TEMPLE CITY BLDG. DIST. NO. 5

PROFILE ALIGNMENT AND GRADE OF P.C. 5925
 SANITARY SEWERS PAGE 1
 TO BE CONSTRUCTED IN JAN. - 0356.17
 R/W WEST OF LAKE KNOLL DRIVE

PRIVATE CONTRACT NO. 5925

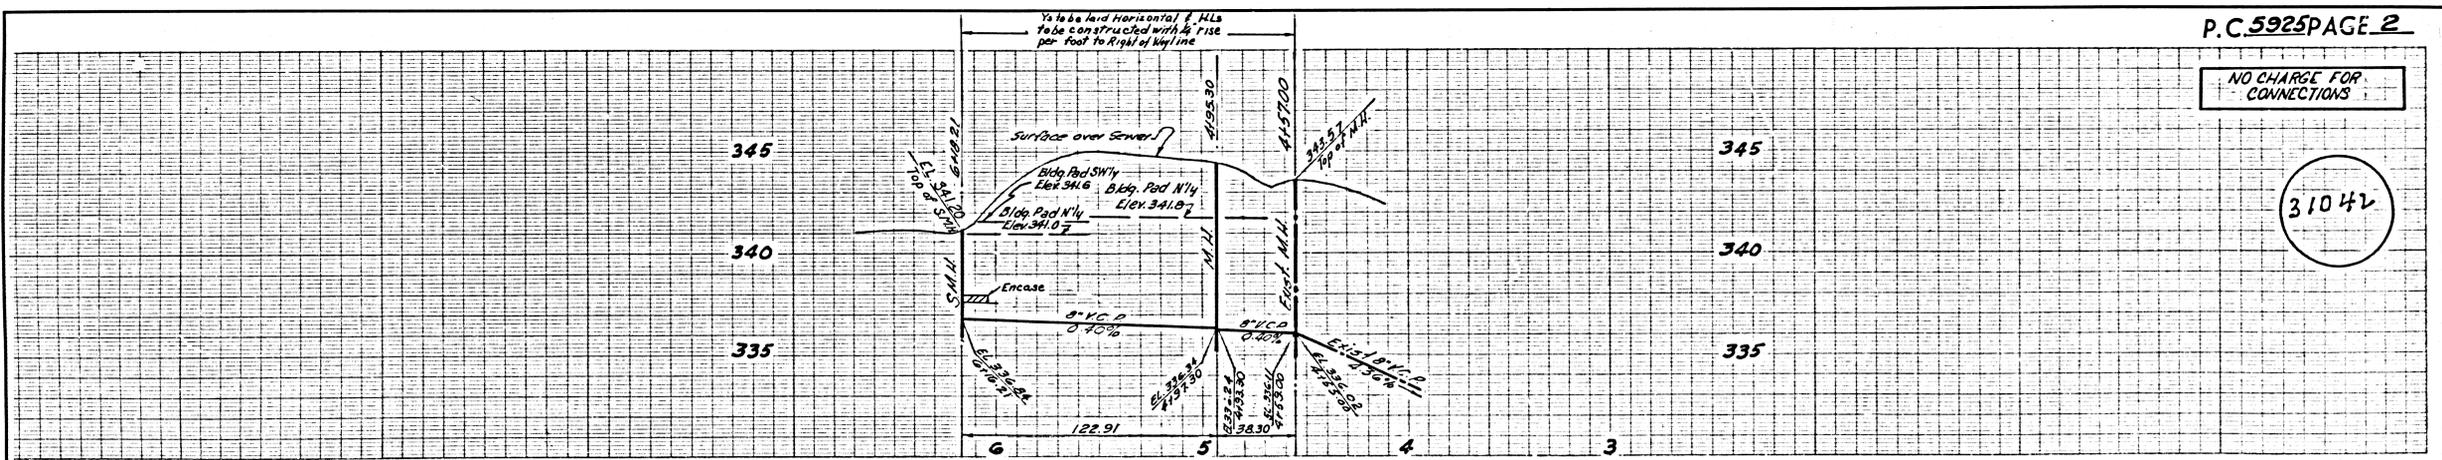
REVISION
 Relocate M.H. at Sta. 413473
 4' Northerly due to interference
 with retaining wall
N. F. Brannan
 SAN GABRIEL VALLEY REGIONAL
 ENGINEER
 9-20-61
 DATE
